# **8x930Hx (8x930HD, 8x930HE) SPECIFICATION UPDATE**

Release Date: March, 1997

Order Number: 272962-006

The 8x930Hx may contain design defects or errors known as errata. Characterized errata that may cause the 8x930Hx's behavior to deviate from published specifications are documented in this specification update.

**Figure 1. RST Source From  $V_{CC}$  and  $V_{BUS}$**

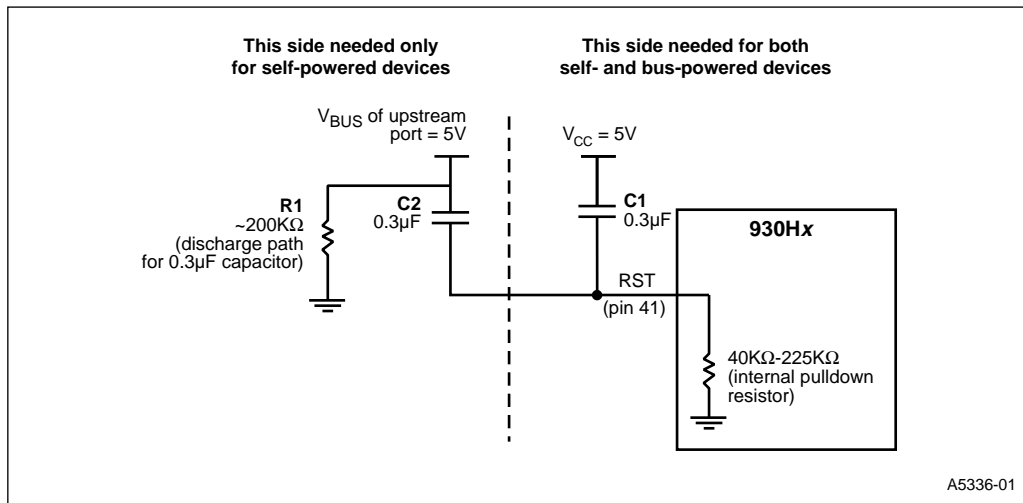
**PROBLEM:** When a self-powered, suspended hub is reattached to the host, it could be accidentally recognized as a low-speed device. This is caused by the 8x930Hx A-1 driving K signaling upstream and the host incorrectly sampling the speed of the device immediately after connect instead of after USB reset.

**IMPLICATION:** Enumeration will fail due to the host sending low-speed packets to a high-speed device.

**WORKAROUND:** To fix this problem, you must modify the reset circuitry on current 8x930Hx designs. Figure 1 depicts two circuits, one for a bus-powered hub and another for a self-powered hub. For bus powered devices, the circuit is the same one that is given in Figure 14-1 on page 14-1 of the *8X930Ax, 8X930Hx Universal Serial Bus Microcontroller User's Manual*, except the capacitor value has been changed from 1.0  $\mu$ F to 0.3  $\mu$ F.

For self-powered devices there are two requirements:

- The reset circuit design needs to be activated when the board is first powered-on.
- If the board is already powered-on, then a connection to the host should initiate reset. By connecting another capacitor to  $V_{BUS}$  (C2, as shown in Figure 1), a reset pulse is sent to the chip by either a power-up or by a USB connect.

- C1 — Used in conjunction with the internal pull-down resistor to generate a 20 ms pulse of reset. For bus-powered devices,  $V_{CC} = V_{BUS}$ . This creates a 20 ms pulse upon connection to the host. For self-powered devices, a 20-ms pulse will occur regardless of the state of  $V_{BUS}$  if the capacitor ratios remain 1:1. The circuit operation and timing relationships rely on  $C1 = C2$ .
- C2 — Used only for self-powered devices. The capacitor delivers a 20-ms pulse to the RST pin when the  $V_{BUS}$  signal is detected upon device connection.
- R1 — Provides a discharge path for C2. This resistor is mandatory. If R1 is not present, C2 will not discharge the reset pulse and therefore will not allow a proper chip reset during device connection.

Figure 4. External Code Fetch, Nonpage Mode

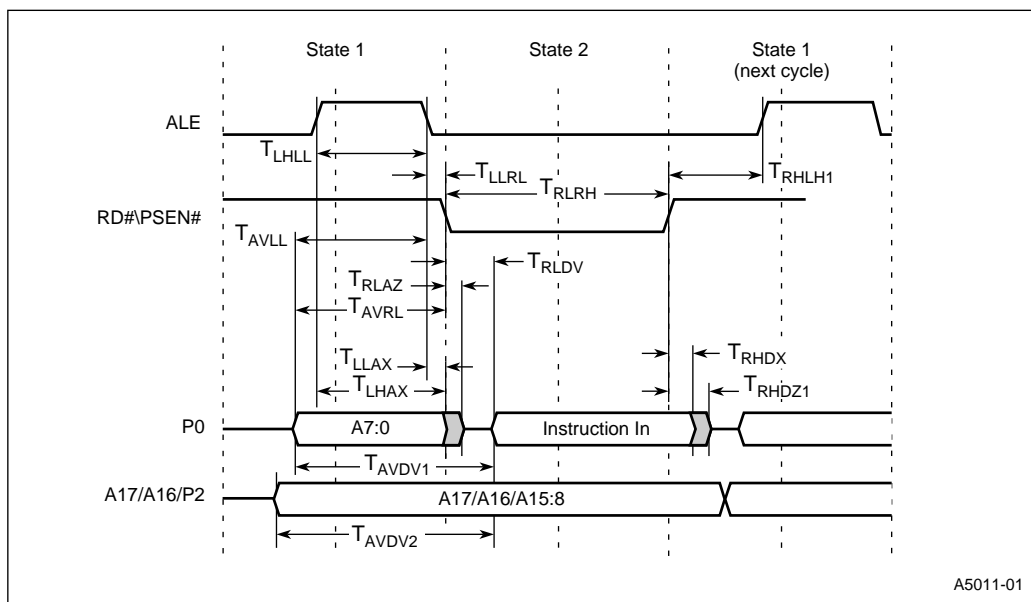
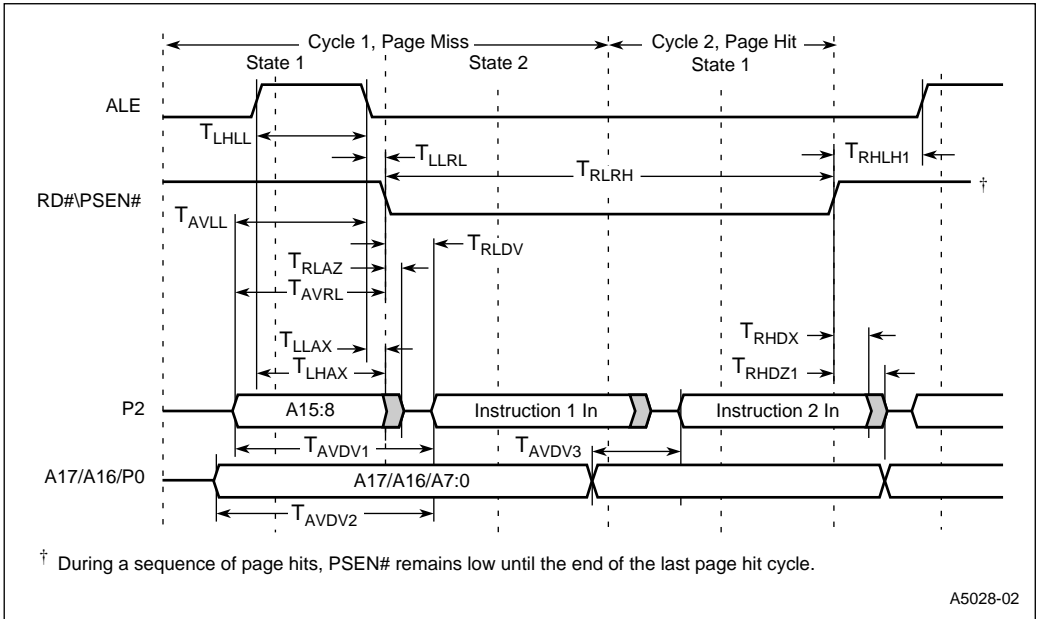
**PROBLEM:** The  $T_{RHDZ1}$  (Instruction Float After RD#/PSEN# High) specification on the 8x930Hx when operating at 12 MHz is 10 ns. However, a slow memory device such as an EPROM typically takes approximately 30 – 90 ns to float its output. (This specification, generically called  $T_{PHZ}$ , may vary depending on the memory type and manufacturer.) Figures 4 and 5 illustrate the  $T_{RHDZ1}$  timing.

The difference between the  $T_{RHDZ1}$  and  $T_{PHZ}$  specifications causes contention on the data bus (P0 in nonpage page, P2 in page mode). The 8X930Hx begins to drive the address for the next bus cycle while the memory device is still driving data from the previous bus cycle.
